Advice/Comments

Please see latest Flood Maps from the SELincs SFRA noe being used by SHDC.

**img20180720_15405905.pdf**
381K

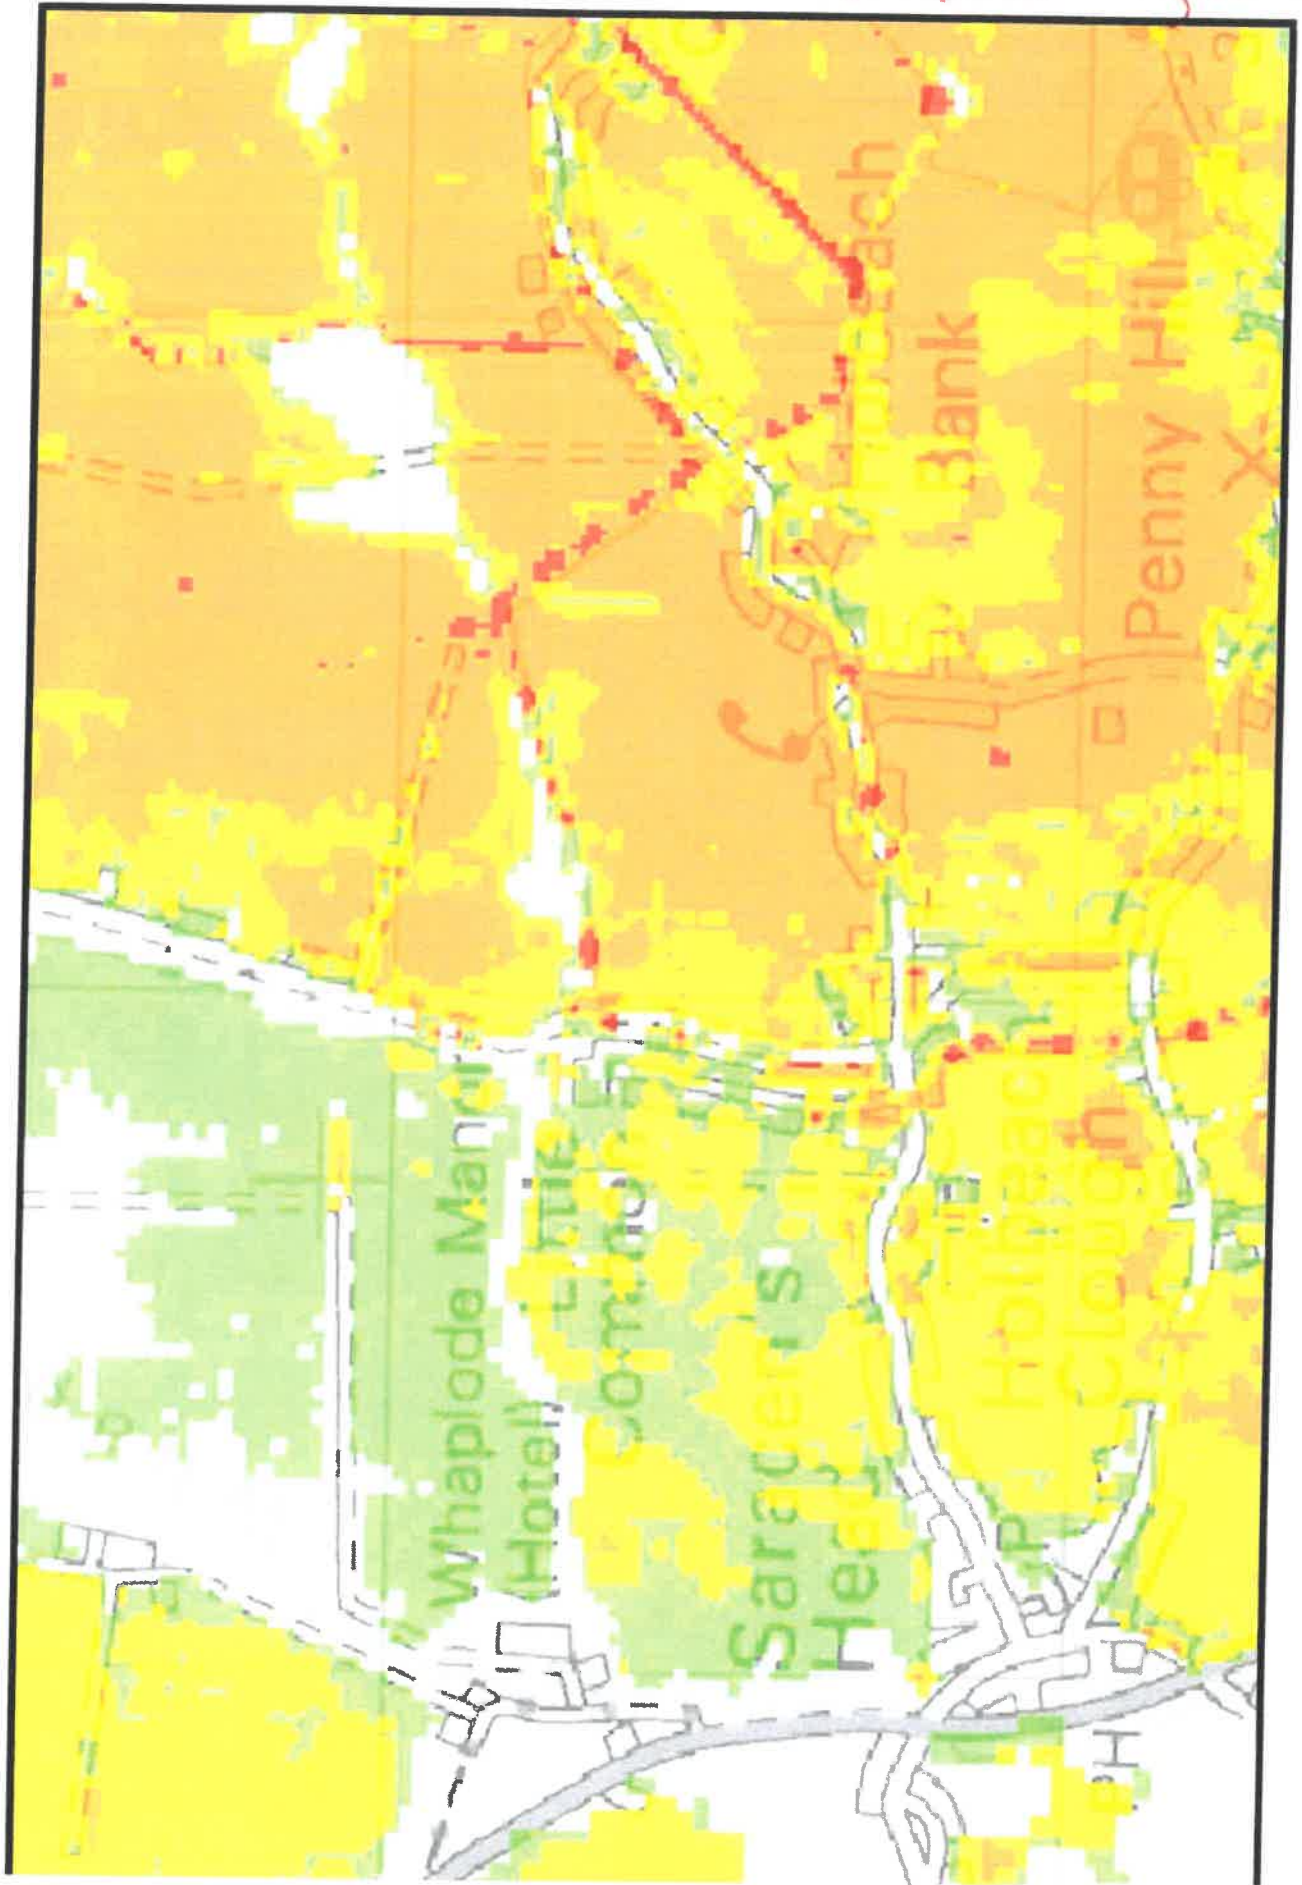
The site is in Low Hazard so meets the Sequential Test and if FFL.s are raised 300mm above Little Common Lane carriageway should also meet the Exception Test.
